Planning Assessment Officer Report

PA2604213 – 26-36 Princess
Street, Kew and 11-15 Brougham
Street, Kew

Planning Assessment Officer Report
Development Assessment

Above: Section diagram demonstrating various overlooking mitigation measures.

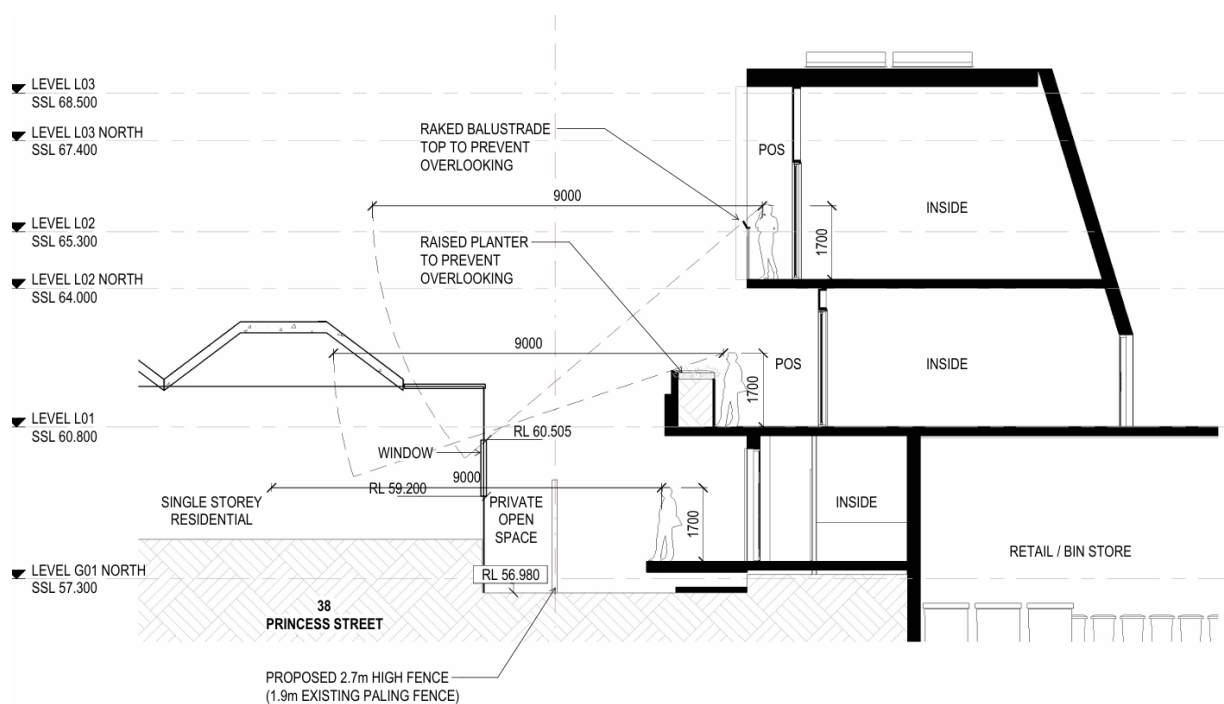
95. Notwithstanding the above, the following is noted and is recommended to be addressed by conditions:
- The planter boxes shown to obstruct views on Level 1 of the townhouses in the section drawings is not reflected on the elevation plans. A condition is recommended to be included on the permit to ensure the elevations are consistent with the sections and overlooking measures are shown.

- Views from the central Level 1 communal garden of the townhouses and the lower stair landing into adjoining private open space may occur, despite the proposed 2.7m fence height. A condition is recommended to be included to secure an increase to the northern balustrades to 1.7m to limit overlooking. This is an appropriate change, given the garden area will have relatively un-obstructed southern views.
